DRAINAGE AND TRANSPORTATION INFORMATION SHEET

RE: **Parking Lot for 6th St/Fruit Ave**
6th St/Fruit Ave
Grading and Drainage Plan
Engineers Stamp Date 8/4/15 (J14D177)

RE: **Fruit Parking Lot**
605 6th St NW
Grading and Drainage Plan
Engineers Stamp Date 8/18/15 (J14D177)

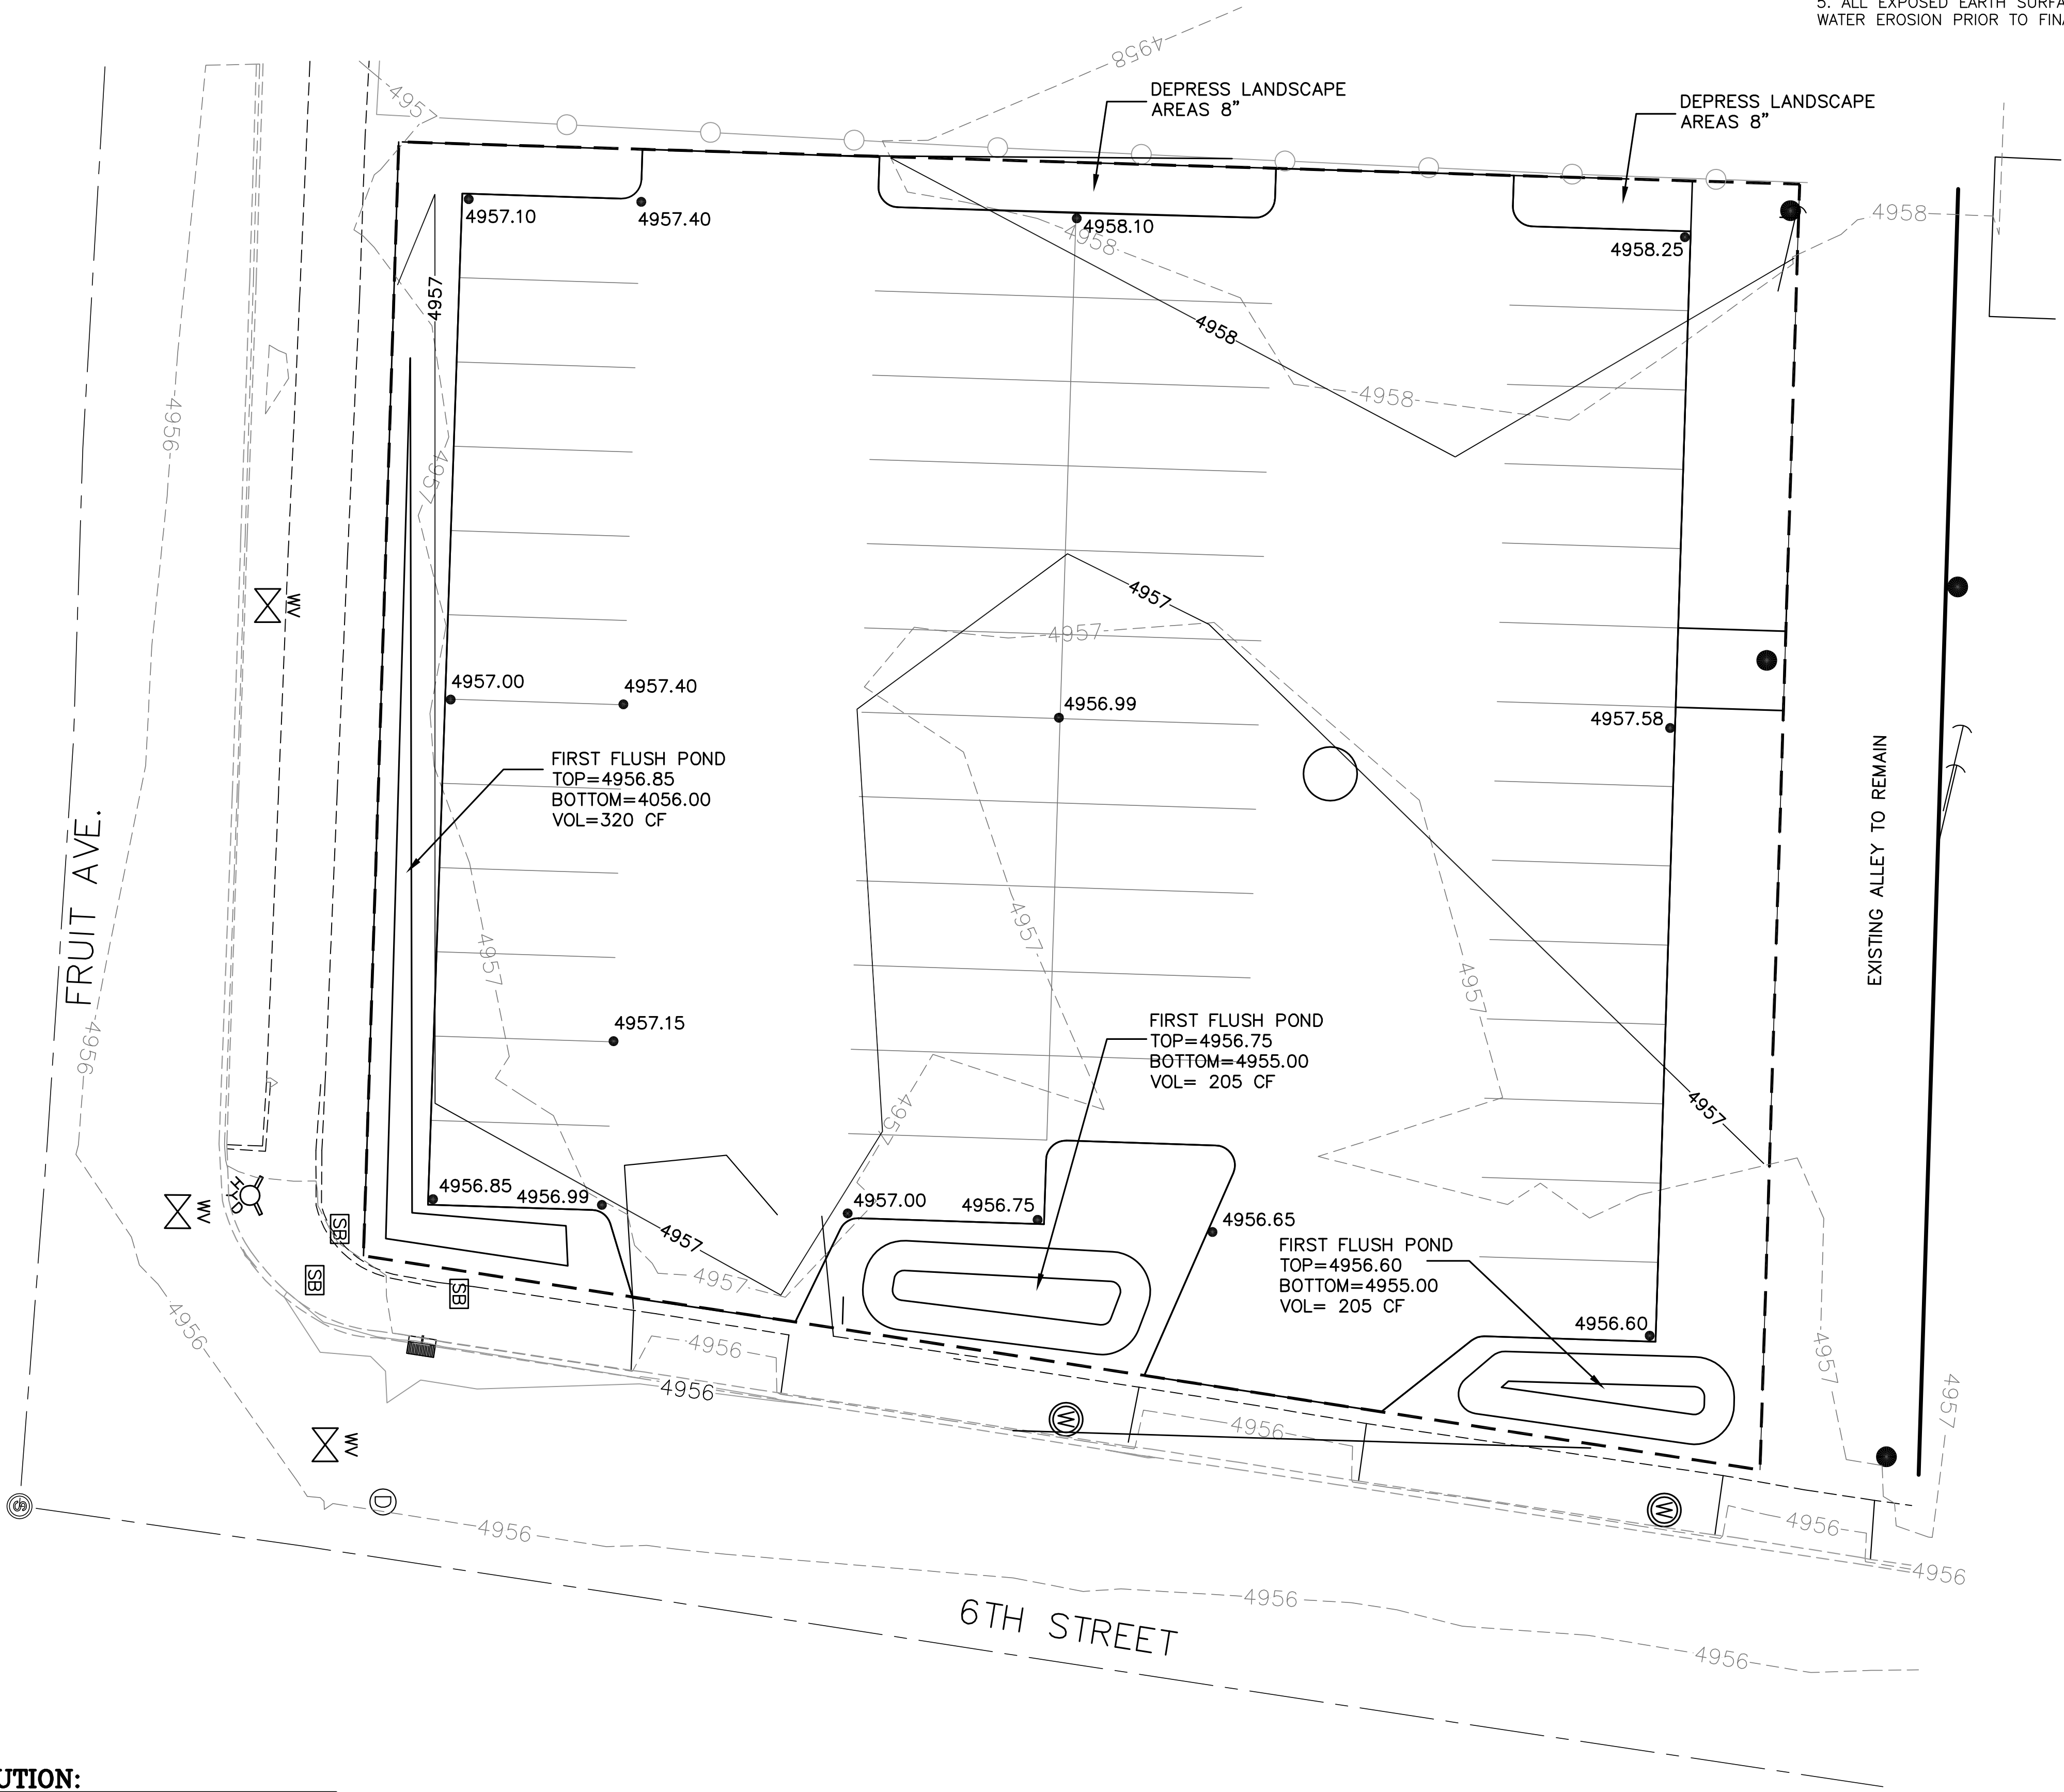
- Provide a larger font for the Drainage Calculation Sheet. **ADDED**
- In the narrative a new home being built is mentioned. Where is the home located in this parking lot? **CORRECT NARRATIVE ATTACHED**
- The first flush pond to the south shows a TOP = 4957.00 and a BOTTOM = 4056.00, I hope this is a typo, adjust accordingly. **CORRECTED**
- The three ponds to the east have a TOP shown larger than the spot elevation provided next to the ponds, adjust accordingly. **CORRECTED**
- Is the lot being paved, or kept as is? Are parking bumpers supplied? The alley will need to be paved. A TCL is required. **INCLUDED TCL**
- Provide the benchmark. **ADDED**
- How will erosion, dirt, dust from the parking lot be kept out of the right of way (6th St.)? **INCLUDED LANDSCAPE PLAN TO SHOW GRAVEL**
